SHOP DRAWING APPROVAL
THIS LAYOUT IS THE SOLE SOURCE FOR FABRICATION OF TRUSSES AND VOIDS ALL PREVIOUS ARCHITECTURAL OR OTHER TRUSS LAYOUTS. REVIEW AND APPROVAL OF THIS LAYOUT MUST BE RECEIVED BEFORE ANY TRUSSES WILL BE BUILT. VERIFY ALL CONDITIONS TO INSURE AGAINST CHANGES THAT WILL RESULT IN EXTRA CHARGES TO YOU.

Client:	-			
	Job Name:	POSTON-KATIE LASSEK RES PLAN			
	Model:	24376 ROOF			
	Lot #:	Subdivision:			
Order #:	21-6482-A C Smiley				
Designer:	C K				
Date:	11/9/2021

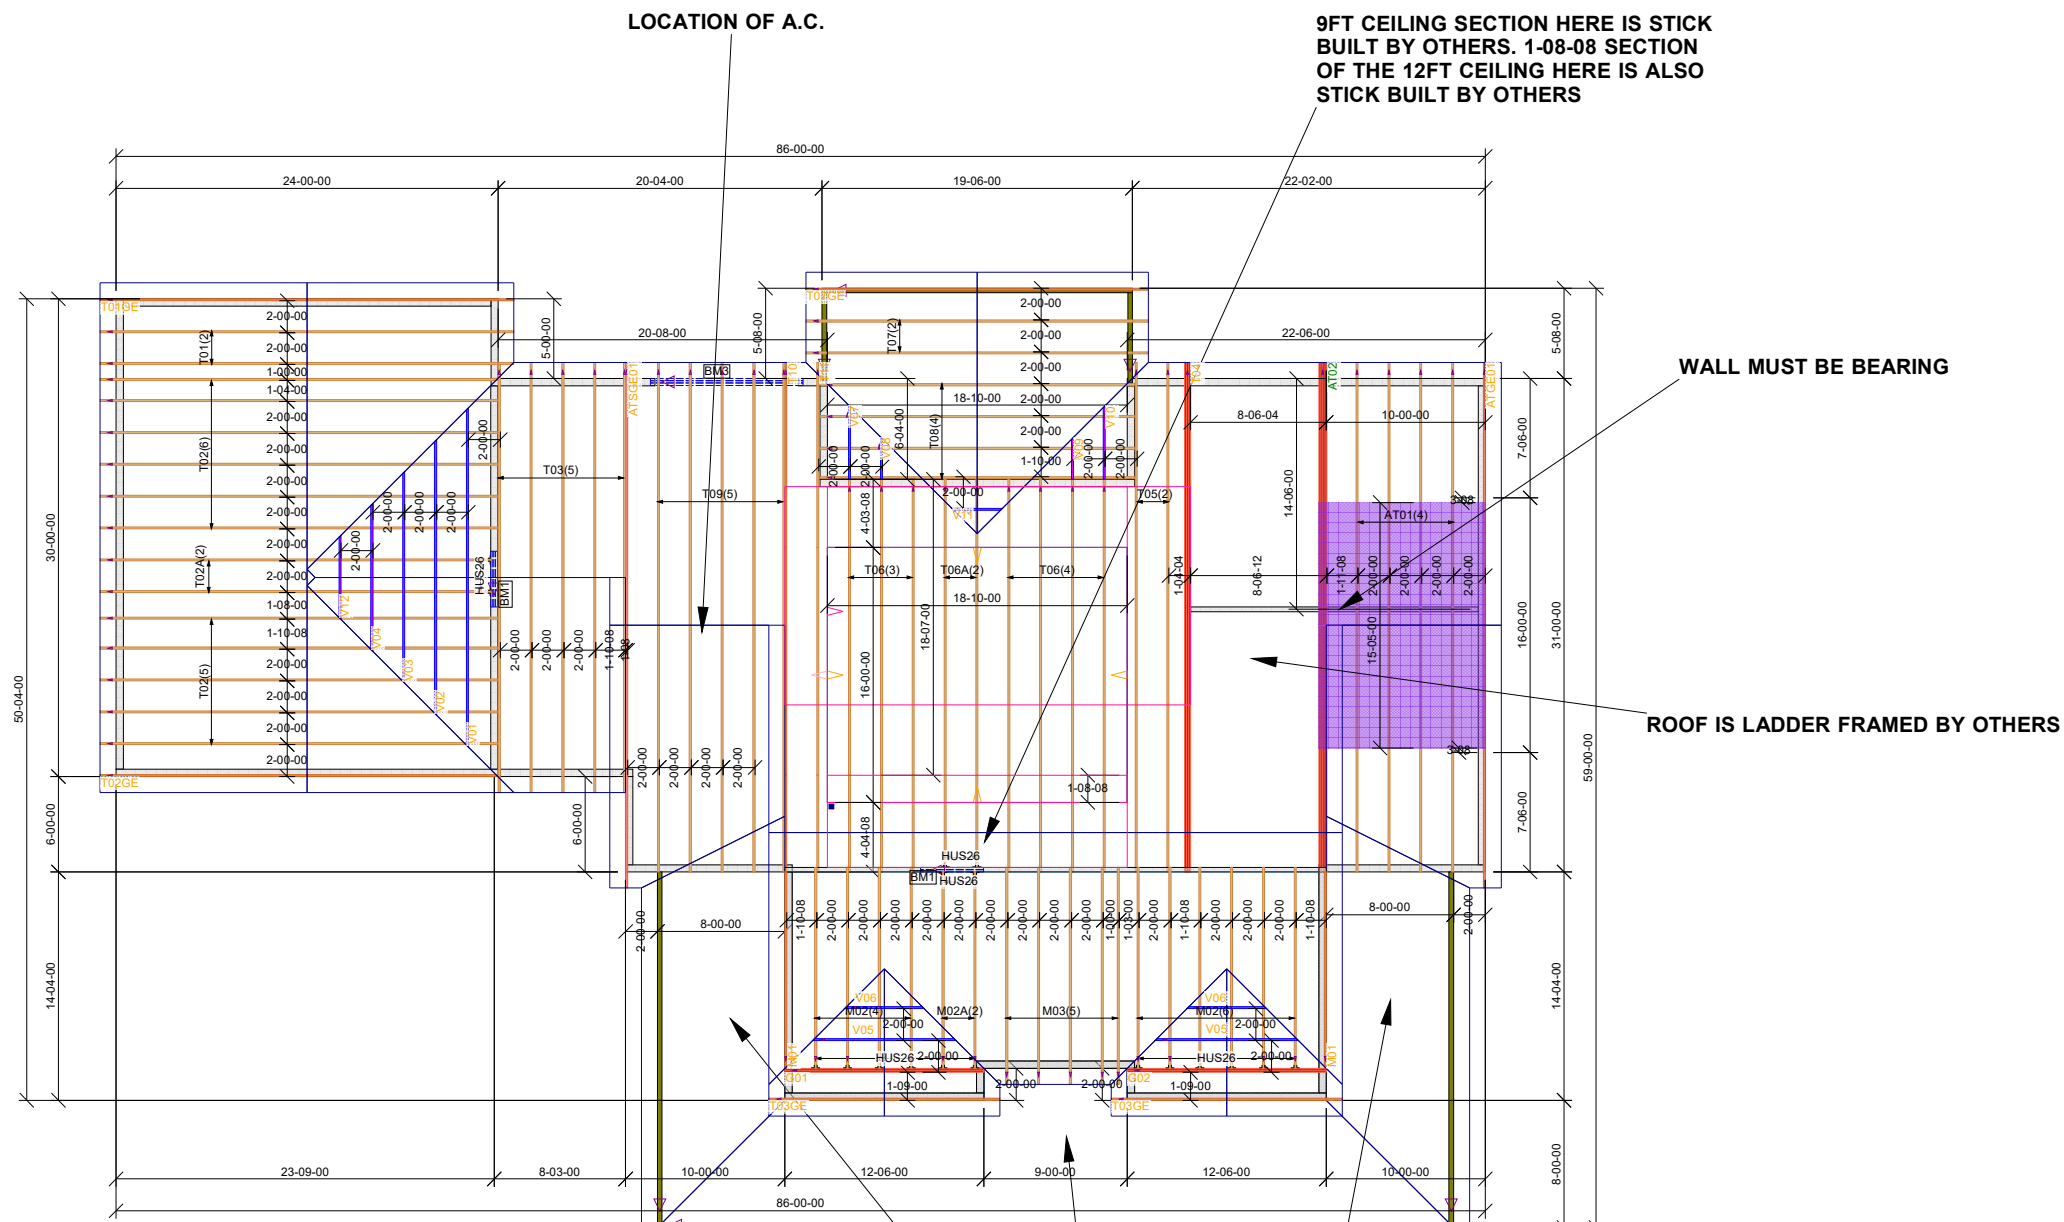
PLEASE VERIFY-

WILL DEPTH OF BM3 WORK(WILL IT BE IN THE WAY OF THE WINDOWS)

HEEL HEIGHTS WILL WORK (HEEL HEIGHTS HAD TO BE MORE THAN STANDARD TO GET ATTIC ROOF TRUSSES TO WORK)

OVERHANG LENGTH

PORCH IS STICK BUILT BY OTHERS (AS TRUSSES RUN THE RISK OF INTERFERING WITH WINDOWS BECAUSE OF HEEL HEIGHTS)

TRAY CEILING DIMENSIONS ARE CORRECT

ARE LOUVERS FALSE, IF NOT WHAT ARE THEIR DIMENSIONS

LOCATION AND DIMENSIONS OF PULL DOWNSTAIRS FOR A/C ABOVE IN GARAGE AND MAIN HOUSE.

IS LOCATION OF A.C. CORRECT
